Board Level Design Review Checklist
Concept Design Review
NARRATIVE

For: TVW Building Expansion
101 Union Avenue SE
Olympia, WA 98501
Project File Number: 23-6823

Staff Markup:
Casey Mauck,
December 2025

SITE CONTEXT ELEVATIONS

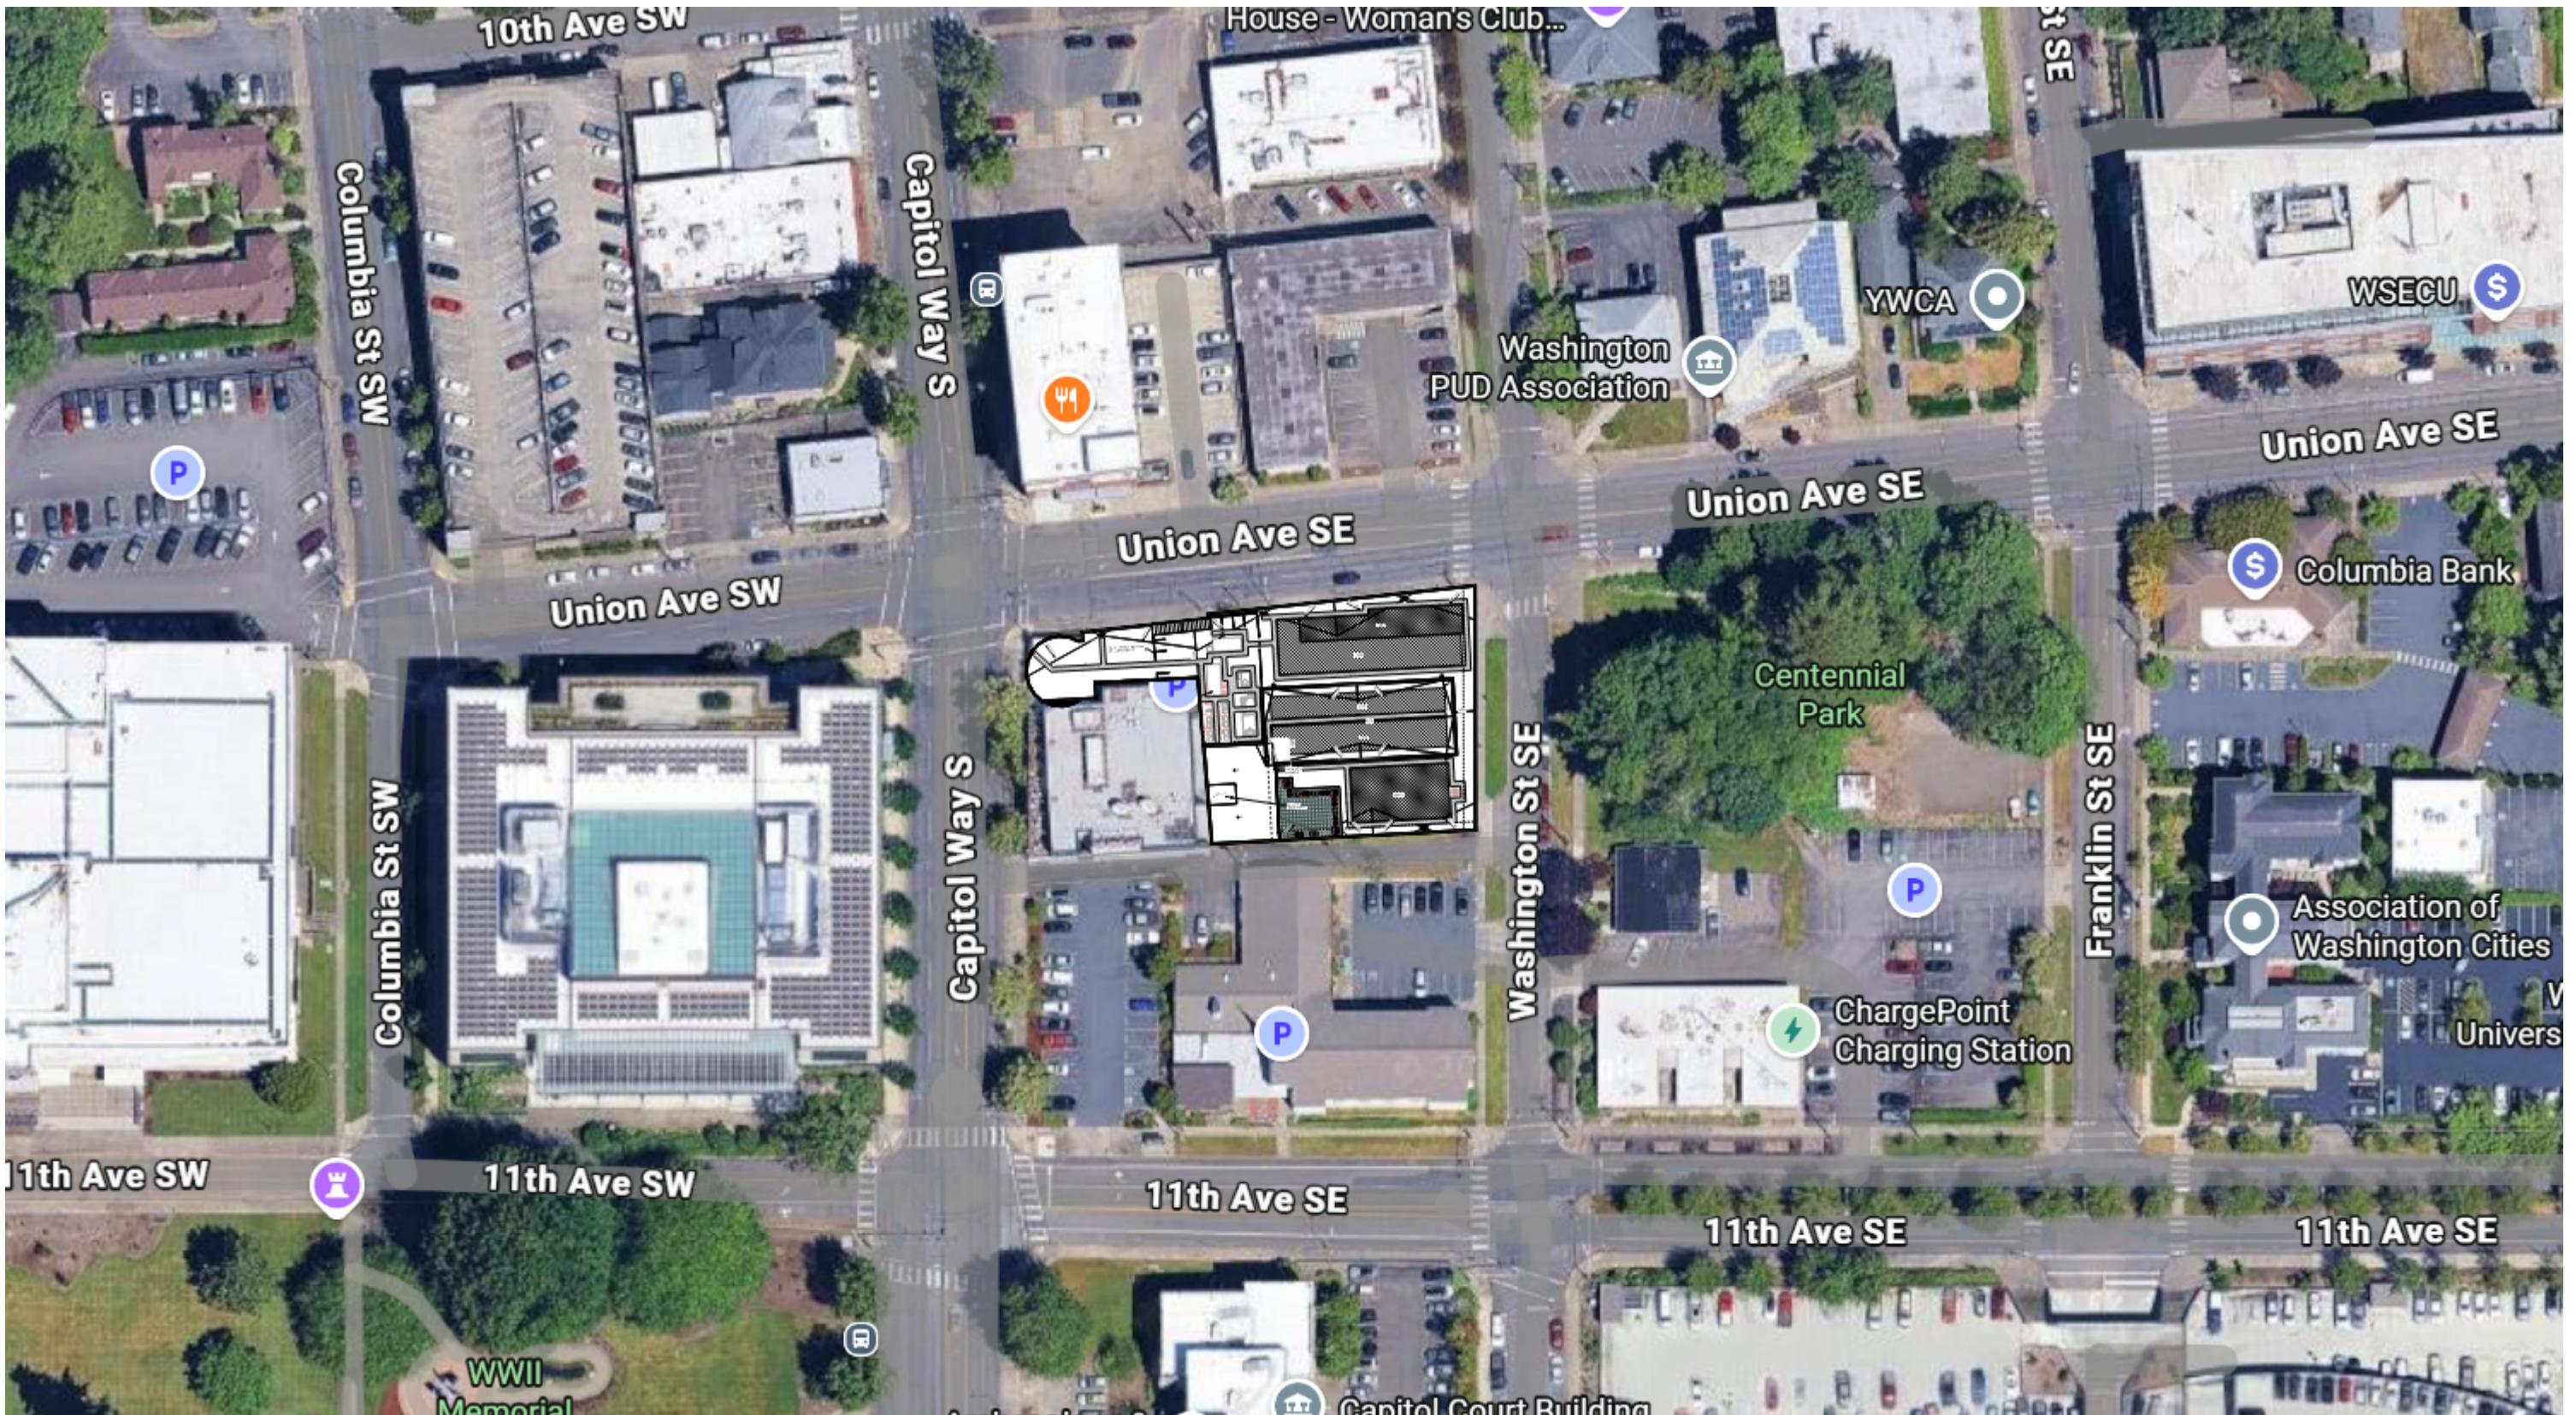
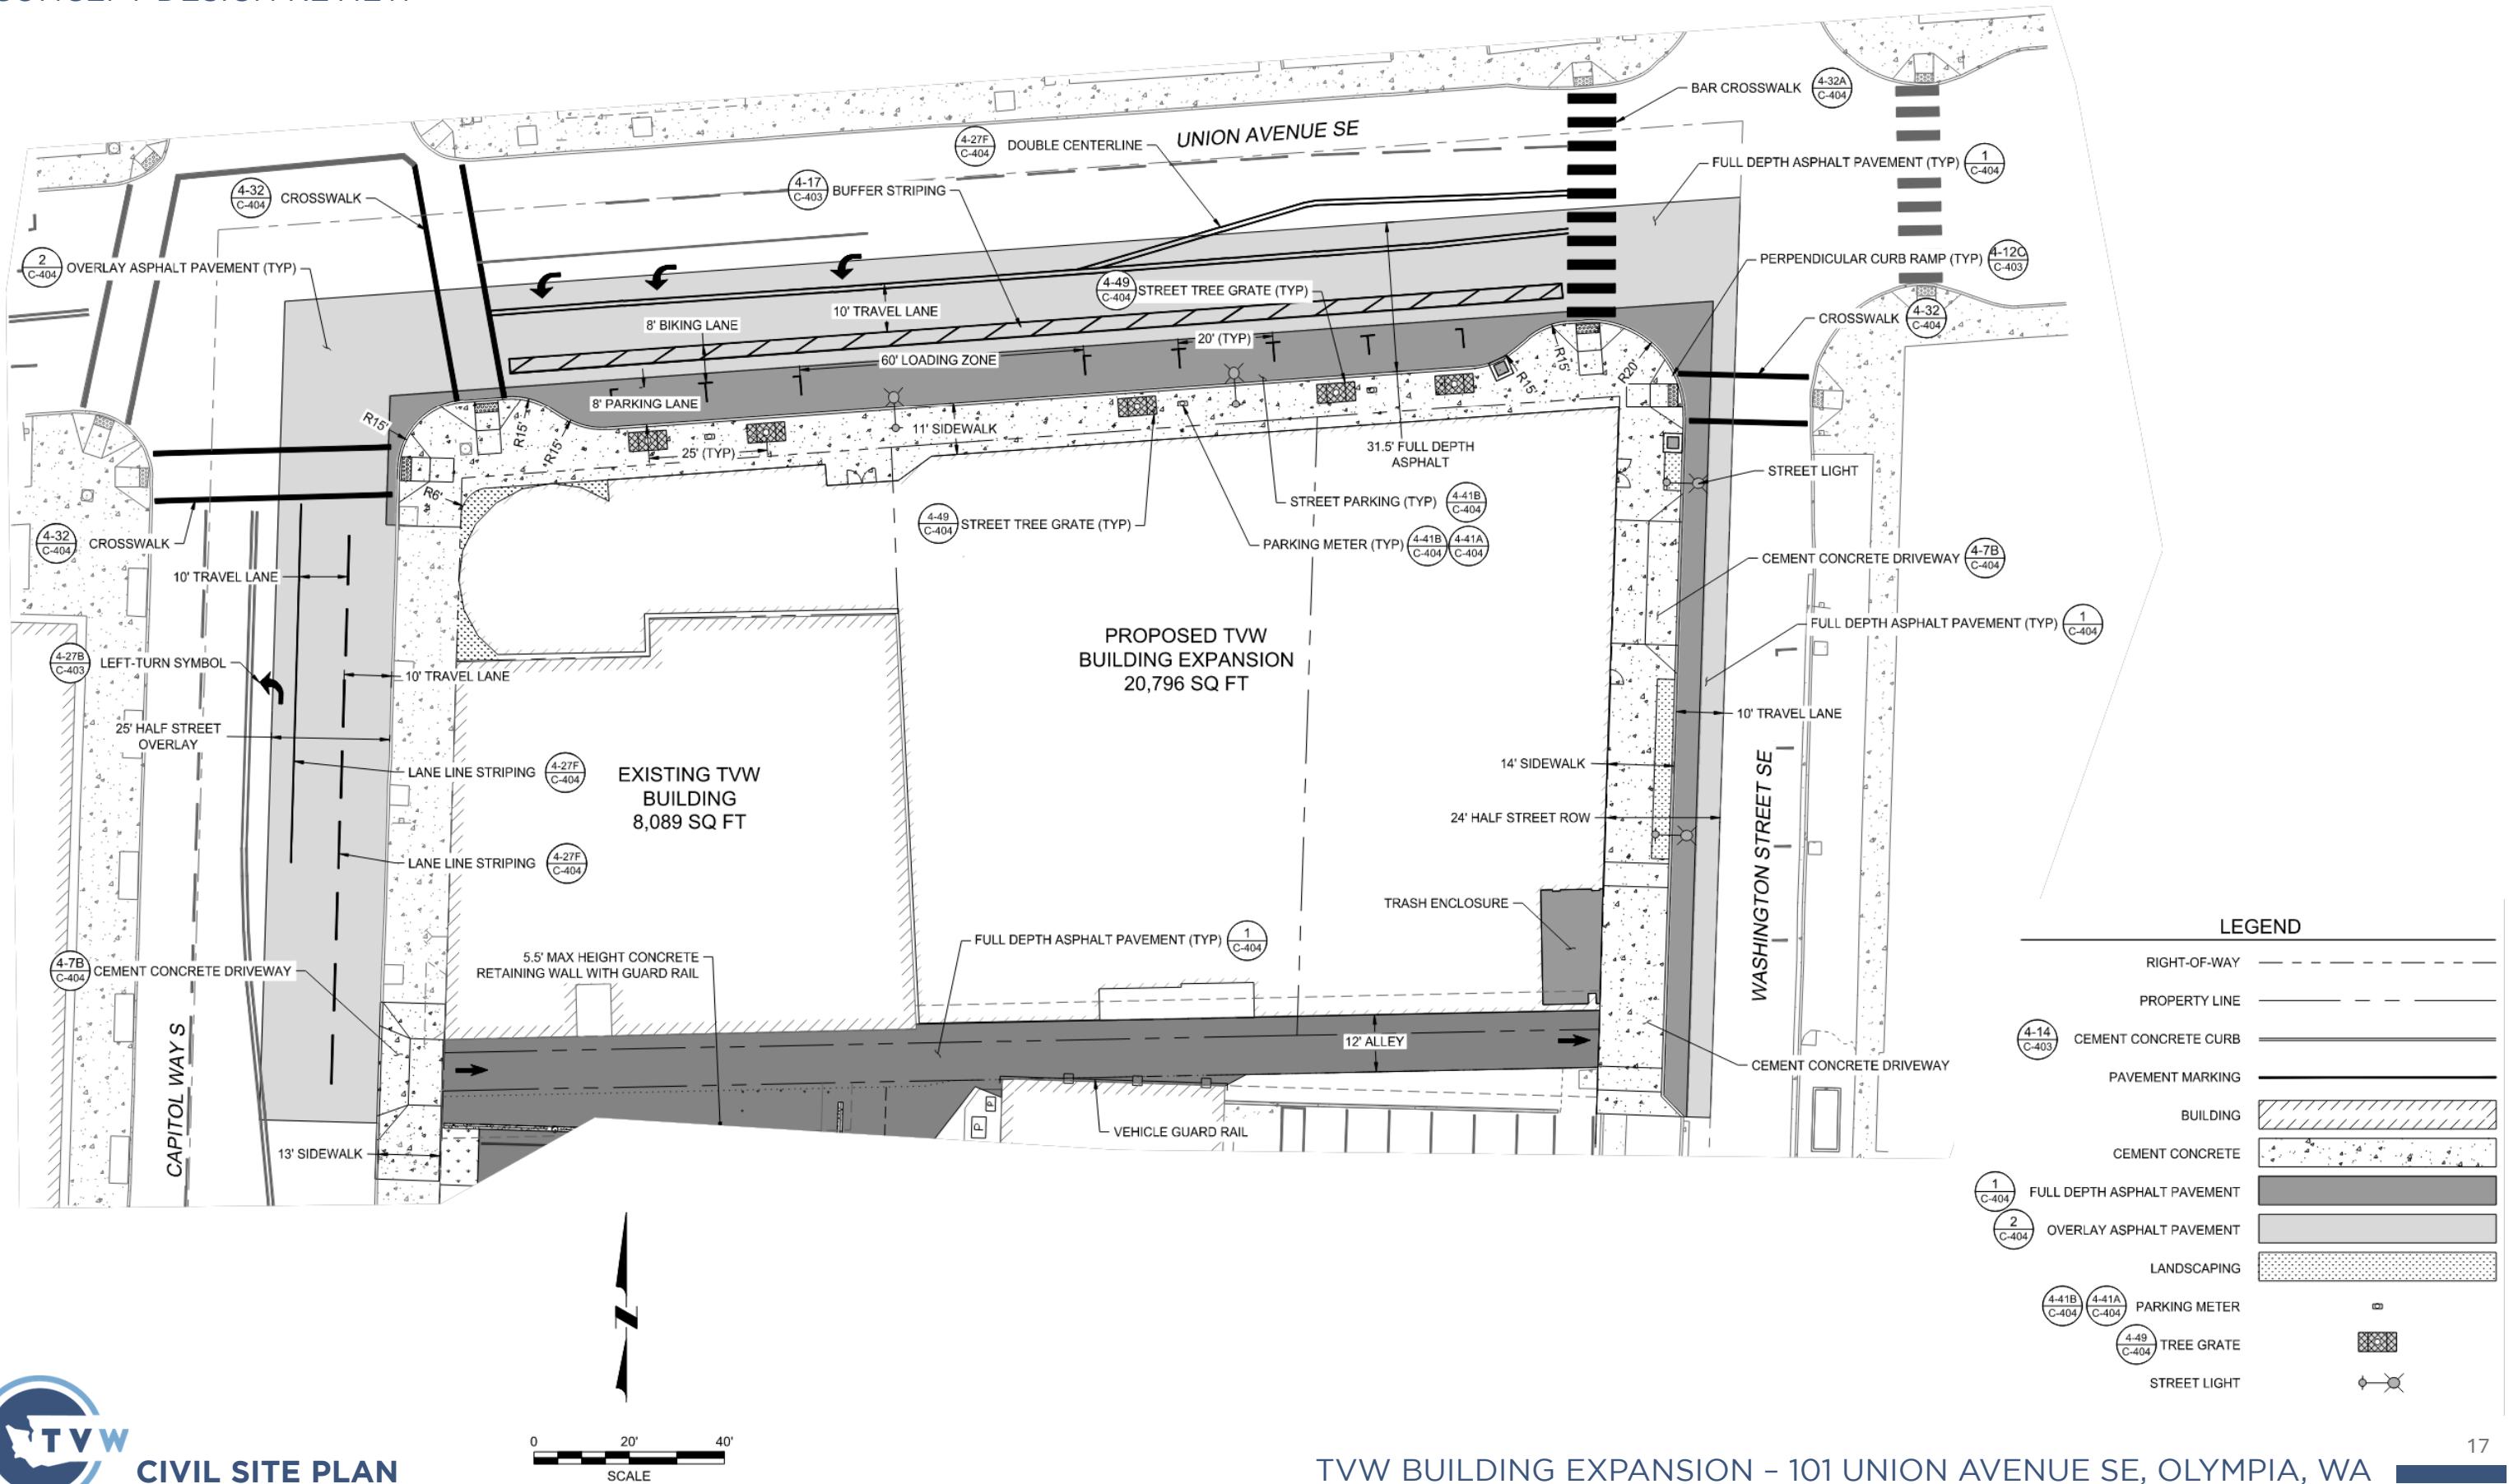
Staff Note: Capitol façade appears to meet criteria. Washington does not appear to have 4 elements from OMC 18.120.440.B.1 that reduce the scale of the façade and add visual interest. Union does not have elements every 30 feet along parking garage frontage.

UNION AVENUE SE - NORTH EXTERIOR ELEVATION 1

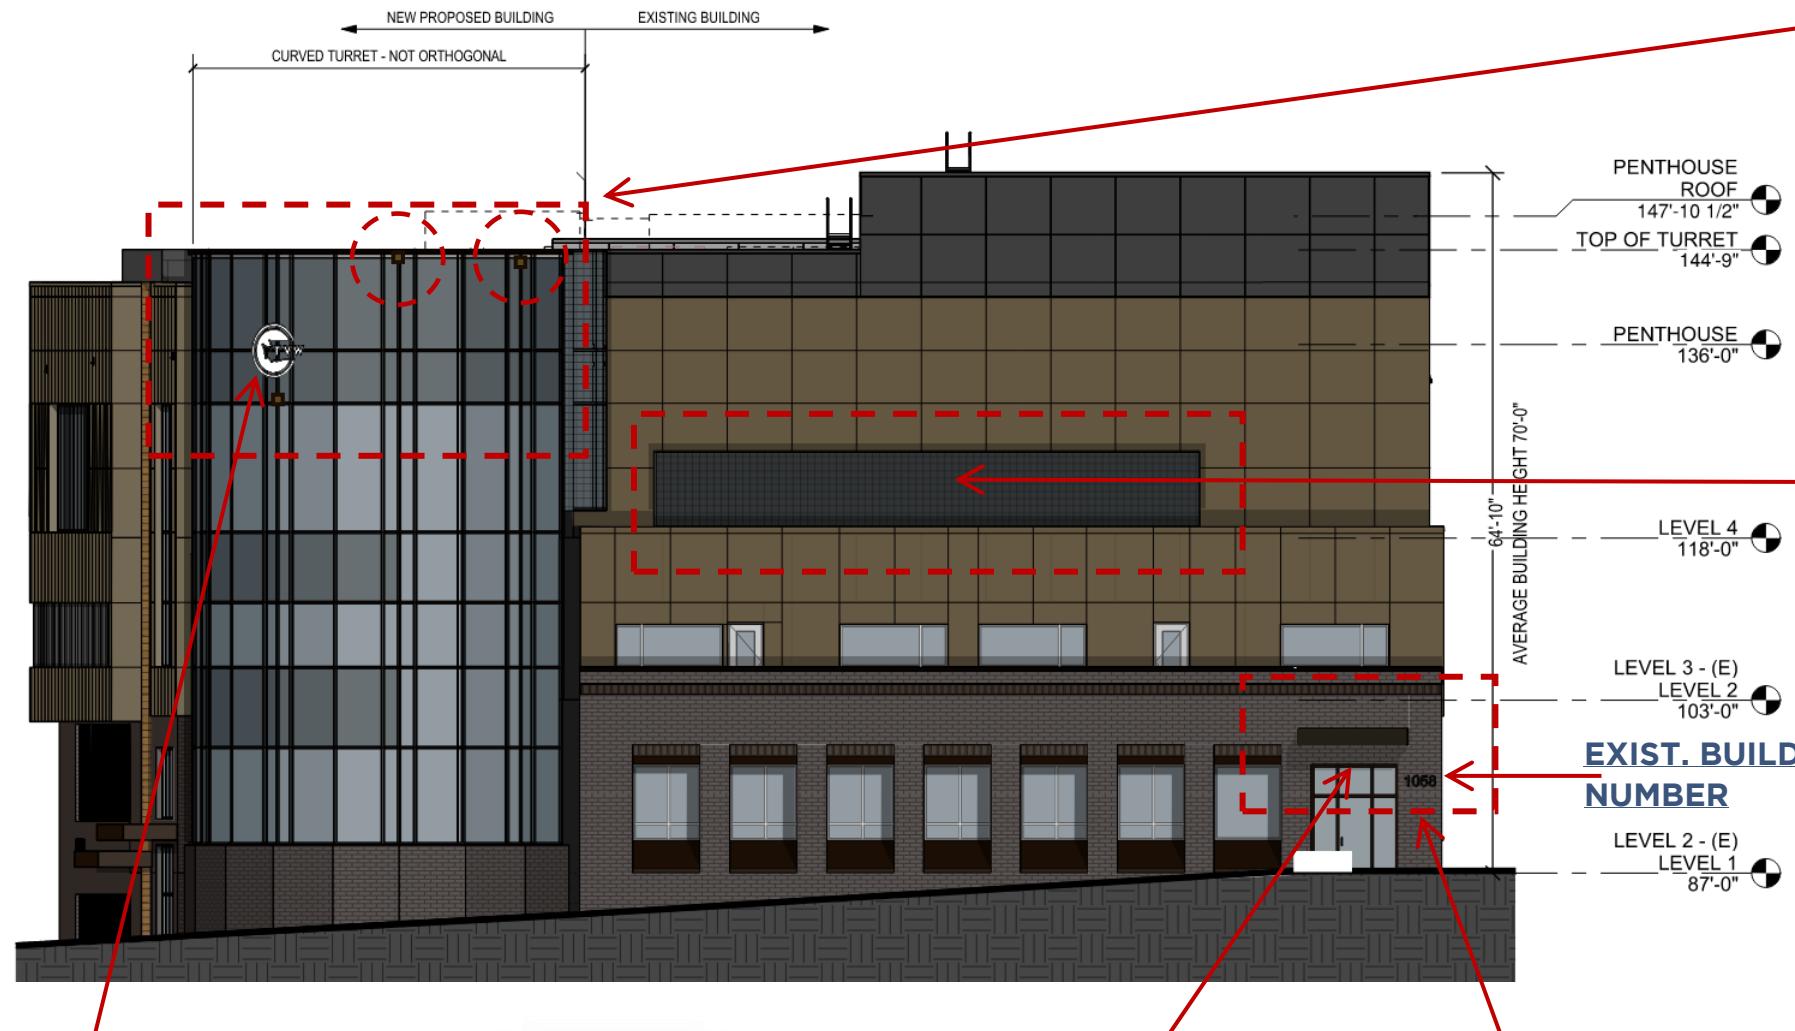
Staff Note: Union façade appears to only be lit on turret side. Capitol and alley façades appear to be missing light along much of the frontages. Page 6
